ADDENDUM 4

ADDENDUM 4 to the Drawings, Specifications, and Bid Package Project Manual, dated **September 12, 2013** for the **Bid Package 05** of the **Ohio University Housing Development Plan – Phase 1**.

RFI #: 027

SUBJECT:	Precast Dimensions & Openings for Mockup		
DRAWING REFERENCE(S):	Attached	SPECIFICATION(S):

1 FLOOR PLAN
SCALE: 1/4"=1'-0"

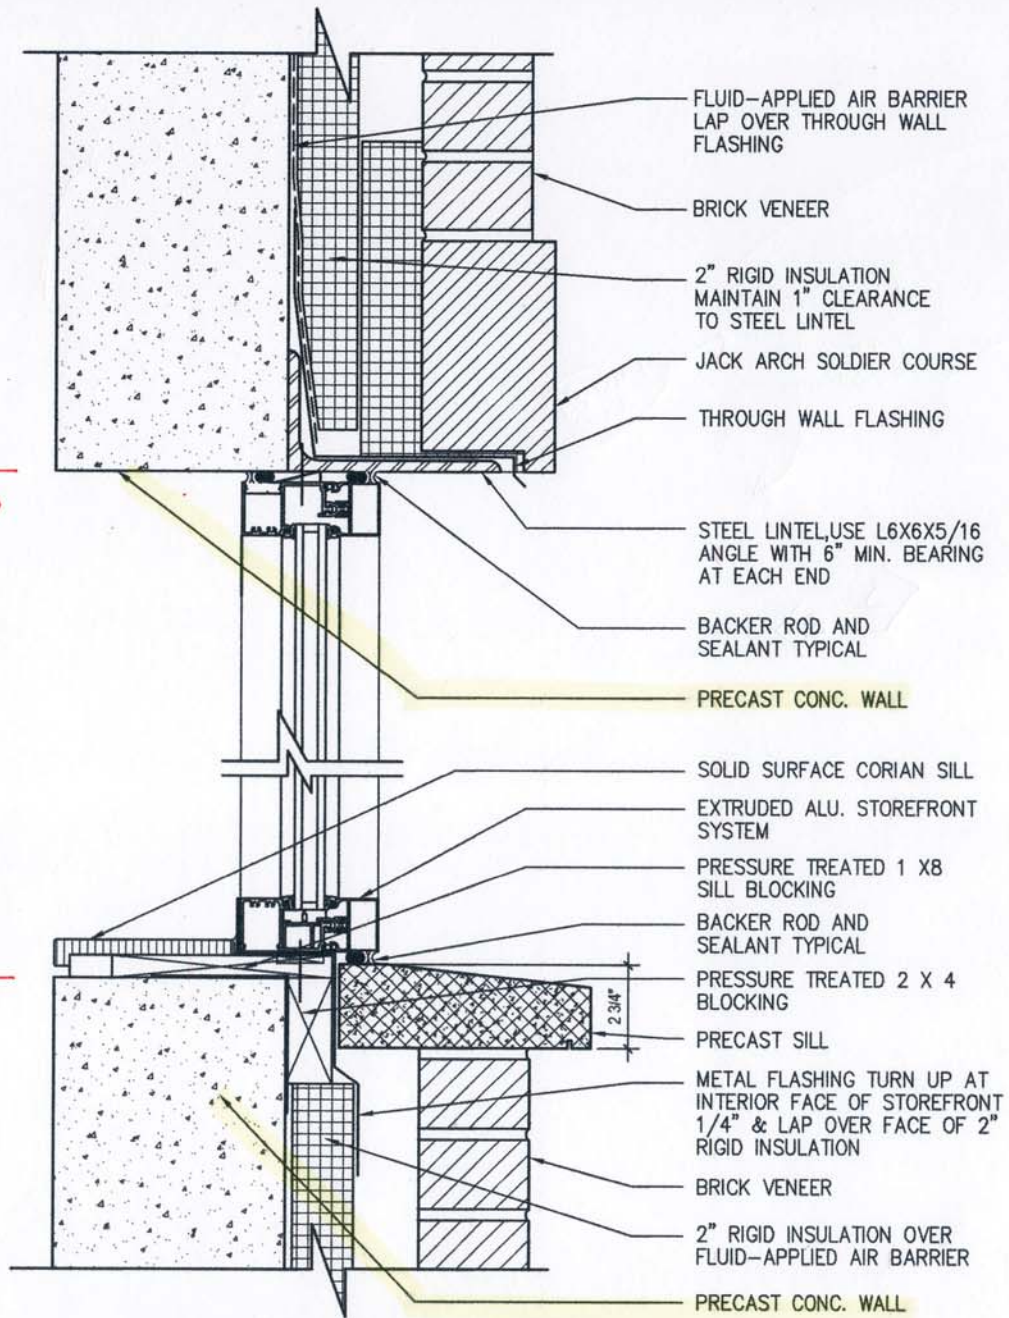
- 1.) Verify that we are only doing the 3 walls that are highlighted yellow on sheet #2. **YES.**
- 2.) Provide the length of the East & West walls. See sheet #2.
- 3.) On the West wall, provide the window locations, rough opening size & elevations from top of existing concrete slab which is 100'-0". See sheet #2 & #3.
- 4.) On the East wall, provide the door locations, & rough opening size. See sheet #2
AE VERIFY DOOR FRAME DEPTH
- 5.) Provide the thickness of the new cast in palce concrete slab as shown in detail 8/A101 on sheet #4. **2" PER MIKE RUSSEL VERBAL CONVERSATION IN OAC MEETING**

1. YES
2. SEE D3_AE401 ATTACHED FOR LENGTH OF EAST AND WEST WALLS
3. SEE ATTACHED FOR DOOR AND WINDOW ROUGH OPENING LOCATIONS, SEE D1_AE557 AND A1_AE557 FOR SILL AND HEAD HEIGHTS
4. SEE ATTACHED FOR DOOR AND WINDOW ROUGH OPENING LOCATIONS, DOOR FRAME DEPTH IS 2.25"
5. 2" PER MIKE RUSSEL VERBAL CONVERSATION IN OAC MEETING
